SUBJECT: JOSEPH M. FARLEY NUCLEAR PLANT, UNITS 1 AND 2, ISSUANCE OF  
AMENDMENT REGARDING MINIMUM CONDENSATE STORAGE TANK LEVEL  
TECHNICAL SPECIFICATION (TAC NOS. ME9293 AND ME9294)

SAFETY EVALUATION BY THE OFFICE OF NUCLEAR REACTOR REGULATION

AMENDMENT NO. 195 TO RENEWED FACILITY OPERATING LICENSE NO. NPF-2

AMENDMENT NO. 191 TO RENEWED FACILITY OPERATING LICENSE NO. NPF-8

Figure 1 - Farley Condensate Storage Tank Suction Pipe Configuration  
(Farley Drawing Number 72-4859)

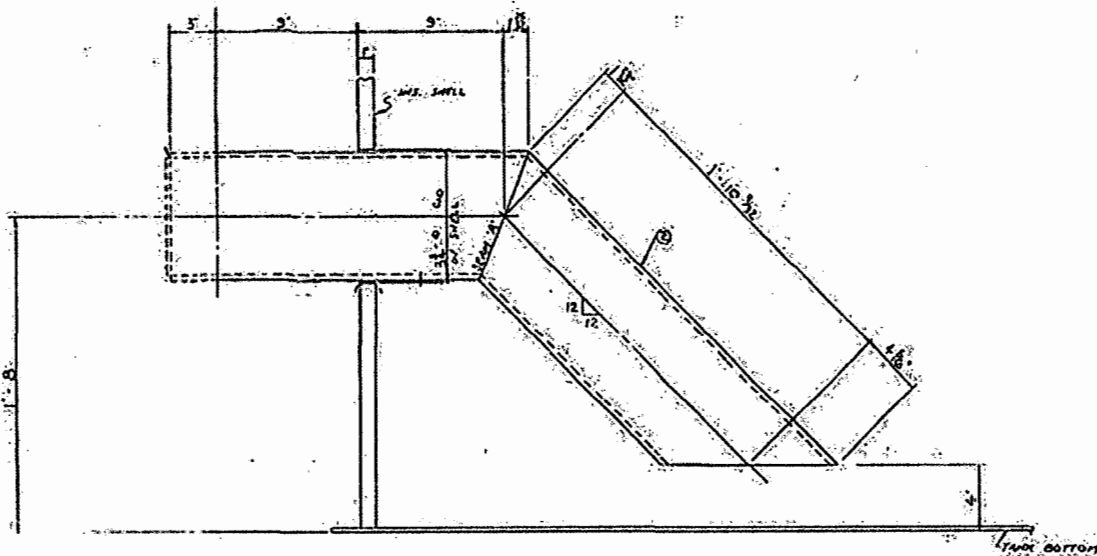
The licensee responded by letter dated October 25, 2012. SNC stated that the critical submergence was calculated using [ ] (Harleman, 1959).<sup>5</sup> The Harleman correlation was developed for a vertically downward configuration (referred to in this SE as the Harleman configuration). The Harleman configuration differs from the 45 degree upward flow pipe installed at FNP. The FNP CST Suction Pipe Configuration is provided in Figure 1.
